DLP3**B0002**

INVERSE TOC FUNCTION DLP WITHOUT KEYPAD

These instructions, GEK-100619 together with GEK-100562, constitute the complete instructions for the DLP3****B0002.

Figure A (0286A2047) Inverse Time Overcurrent Curve for DLP

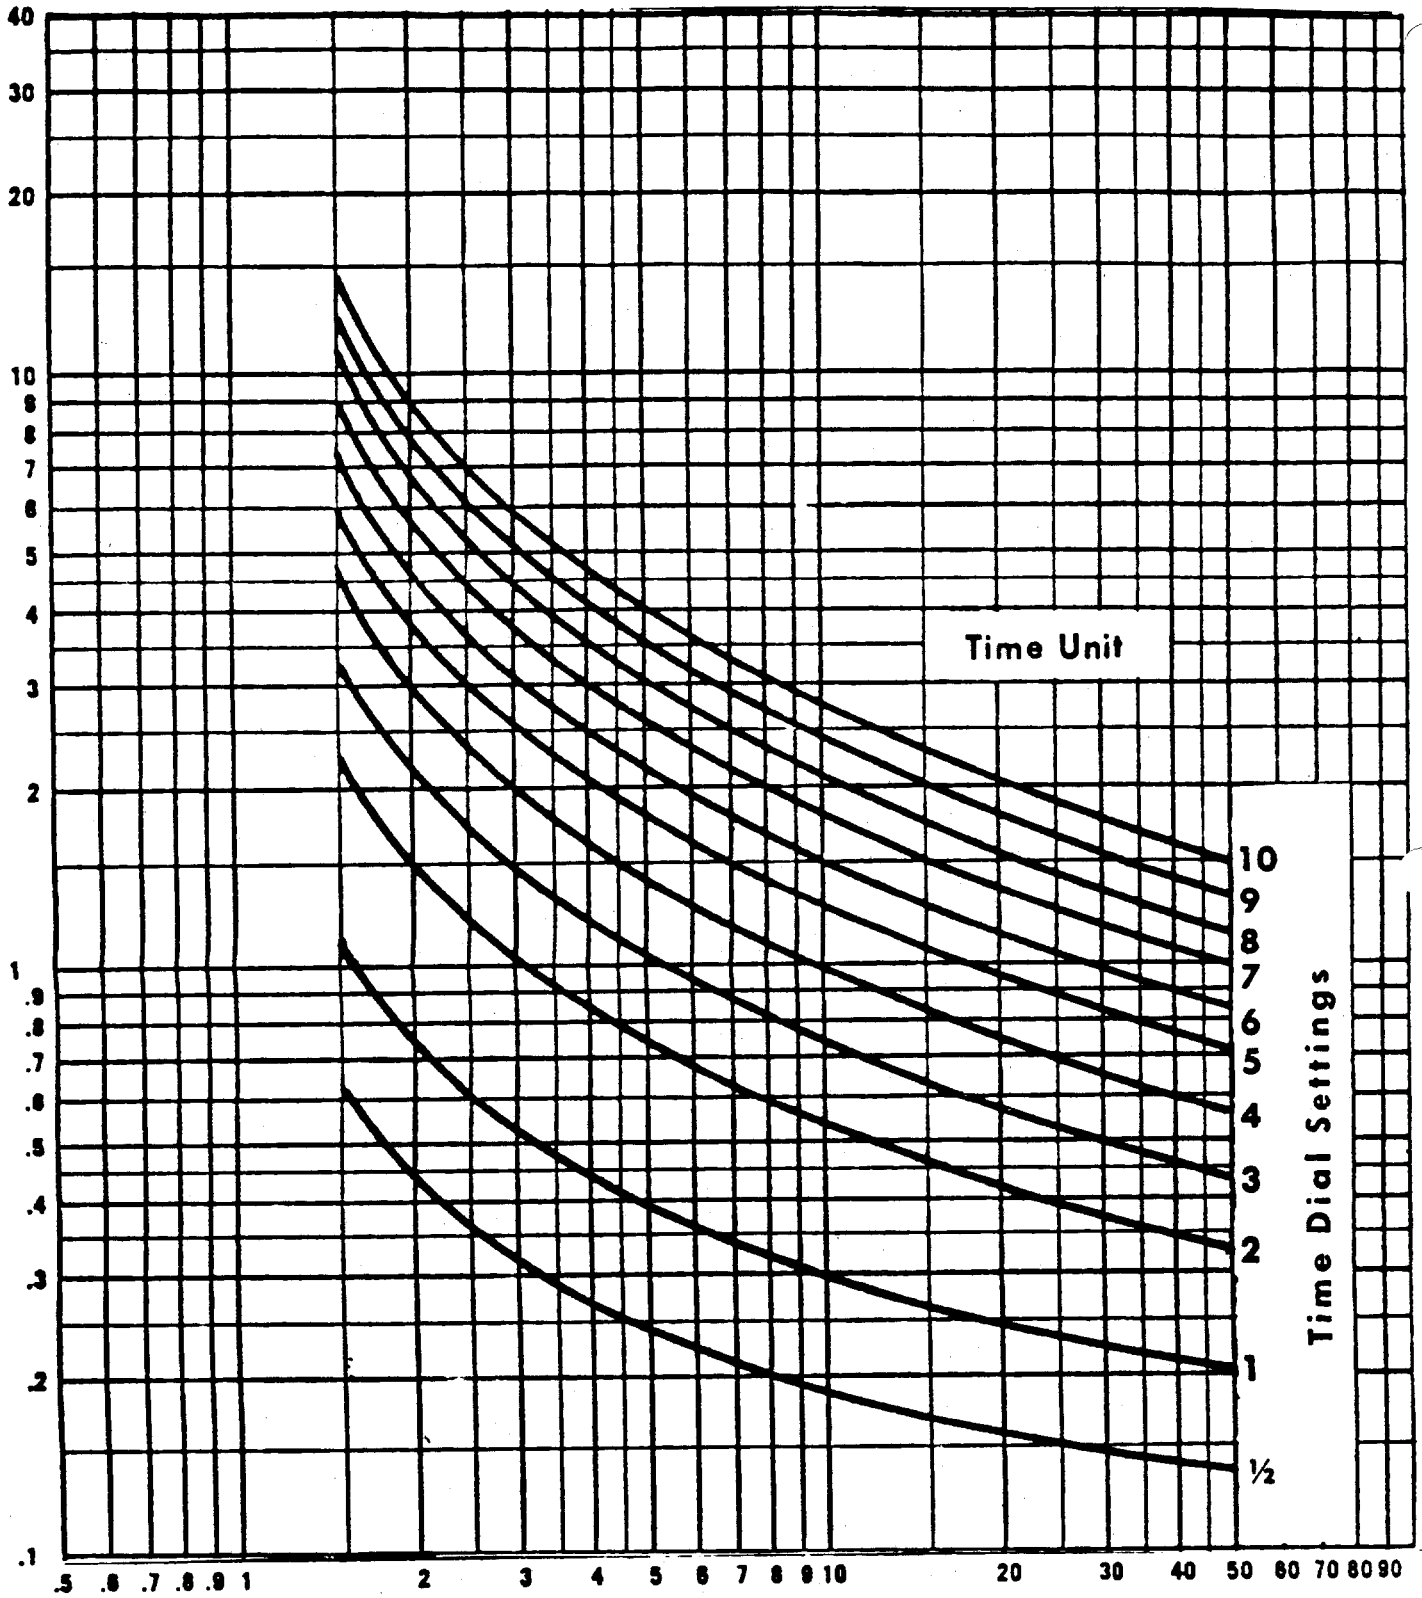
1. The Time Over Current curve has been changed from Very Inverse to Inverse

1. Inverse Time Over Current Curve for DLP for the Calculation of Settings section of the instruction book.
2. Acceptance test section update for DLP instruction book GEK-100562 for TOC test (T8).
- Change time interval from: 2.50 - 3.00 to: 2.00 - 3.00

2. Set the relay into the test mode with TOC selected: "T DLY GND OC ON".
3. Apply Iop at 3.0 amps rms and start the timer. Leave the current "on" until the RC contact closes, and stop the timer. The TOC will time out in 2.00 to 3.00 seconds.
3. Reduce Iop to zero (0).
4. Change the setting of (607)SELDTOC to "YES". Change (608)PUTOC to pretest setting.
